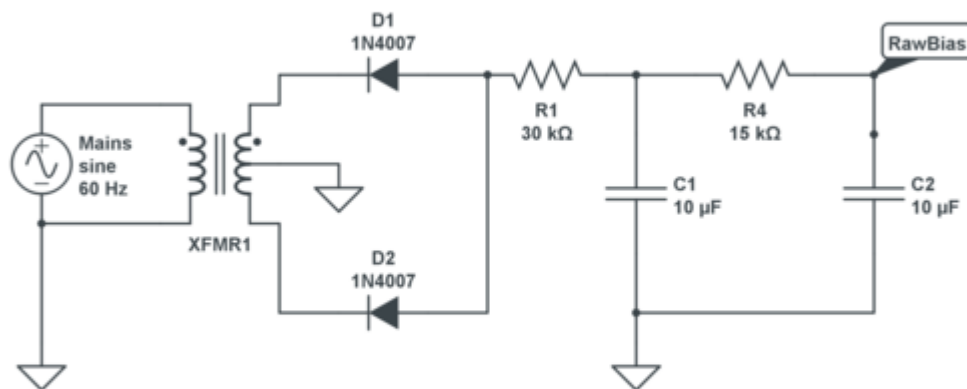
The second issue was a problem with HF oscillation in the tracking circuit. The cure for this, suggested by Merlin, is to add a 220pF cap from base to collector of the NPN pass device in the tracker

Oh. I'm virtually certain that the output impedance of that raw bias supply is simply way too high. You see, the tracking regulator is going to require something like 4 or maybe even 5 mA of current (2 or 2.5 mA through each of the two dividers), and if you try and pull that current through that 220K resistor, you just aren't going to have any negative voltage left.

So, you're going to need to reduce that 220K resistor to something like 33K or so (some fooling around will be required, but it needs to be much smaller). Now, the problem is that you could possibly run into voltage rating issues on those 10uF caps.. I'd go for at least 160V rated parts, though 100V might work in a pinch.

Given the higher than usual current requirement, I strongly advise changing the rectifier to a full-wave rather than just a half-wave.. you need only add one more diode feeding off the other leg of the transformer, so it's an easy patch.

Once you get it sorted out, you might even consider using a carefully chosen Zener in parallel with the first 10uF cap to ensure that the voltage is always clamped to something reasonable for the caps.

Also, make sure to ditch the 47K/25K bias adjust resistor/pot, you don't need those any more.

CIRCUIT
LAB

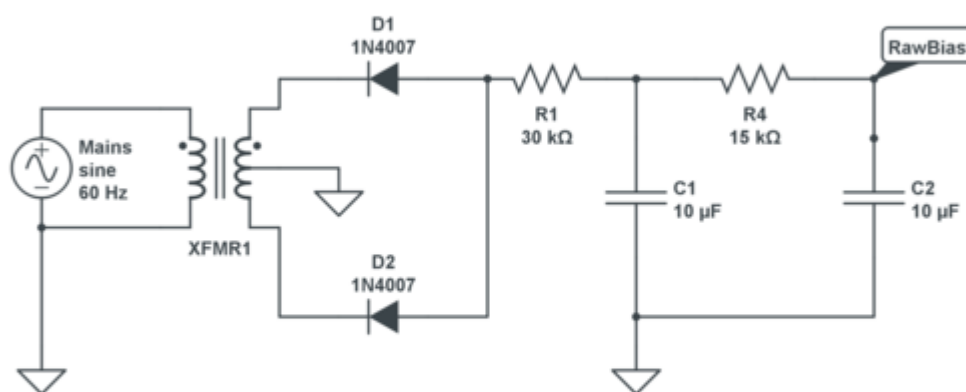
I think there's still a bit of confusion here we need to clear up. It looks to me like you've added the 8.2K resistor in order to ensure that about 4 or so mA of current will be sunk through the 30K resistance (note that since this is a negative supply the rectifier is essentially the sink instead of the source). But you don't need that resistance!! We are not really trying to "provide" current instead of voltage.

To understand what's going on, look for a moment at the first divider in the tracking regulator. You see that at the top, it's seeing something like (say) 420V. But the base of Q1 is held at ground. This means that the emitters of Q1 & Q2 have to be nearly at ground (about 0.7V higher, corresponding to one diode drop from the emitter to base). By Ohm, this tells us immediately that $420V/300K\Omega = 1.4\text{ mA}$ of current is flowing down that divider. Now, a tiny bit of that current normally flows out the base, but almost all of it (this is a transistor after all), will flow from emitter to collector (of Q2 in normal operation). We can make a similar argument for the other divider (in fact, the tracking regulator will, to a first approximation, effectively equalize the current through these two).

Now, that current has to go *somewhere*. But it's obviously not through the tube grids. So the only path is out through the rectifier. That is, the current from the divider has to be sunk by the 30K resistor.

Now perhaps you see the problem we had before with the original 220K resistor. Imagine that we *tried* to sink 3mA through 220K (this won't actually happen in this circuit, most but imagine). The ohmic principle again demands that there be a voltage differential across the resistor -- since we are sinking current, higher on the regulator side than on the rectifier side. 3mA through 220K would correspond to a differential of 660V, which greatly exceeds our available negative voltage!

In reality can't pull it higher than ground however. So the negative voltage we started with from the regulator would be pulled all the way up to something close to ground, and the actual amount of current flowing through the resistor would level out at whatever amount maintained this situation. In this very abnormal mode of operation, most of the current from the dividers would have no choice but to flow out of the base of Q1, and through D1. This is what you saw -- we had no negative bias voltage left to work with.

However, with a lower resistance, we can successfully sink the divider current without losing too much of our negative voltage across that resistor. Does this make sense now?

Incidentally, looking at your situation a bit more carefully, it seems like 30K is unnecessarily low. I think in your case 56K or so should about do it, and this would be a more friendly value for your 10uF/100V caps. Anyway, I'd give that a try, and then lower it if you can't get a sufficiently negative value. When you get things going, I'd also consider messing R8, probably increasing it's value. There's no point in having available settings on the bias adjust pot that will be so hot that it would burn up any tube. You want to have enough range to accomodate the full spectrum of tubes you might encounter, but I like to adjust the range of control on these things so that you can't get yourself into *too* much trouble.

The new raw bias circuit looks OK, but with one proviso. With the circuit exactly the way that it's drawn there, everything will be OK with the filtering capacitors so long as this supply is sinking current as it should. But imagine that something goes wrong with the tracking circuit and there is effectively no current drawn through your 30K R1. With no current, there would be no voltage increase across RA, and as the voltage across the filter capacitors will become extremely negative (like -400V) and they would doubtless self destruct. Now, I'm not suggesting exactly that this has happened, just that if you are having trouble elsewhere with the regulator (or even if you just disconnected this bias supply from the tracker for testing without first modifying it!), bad things could potentially happen to these caps. This is one of the reasons why in an earlier post, I mentioned putting a Zener (100V, say) parallel to one of the filter caps in order to keep the voltage clamped to something safe.

As to the other issues relating to observed voltages, it's difficult for me to speculate, except to say that D1 is critical for keeping Q2 safe. If D1 is installed in the wrong orientation or not functional, Q2 will die during startup. While the indicated 1N4148 should be fine, if you are nervous, you can use a beefier rectifier diode.
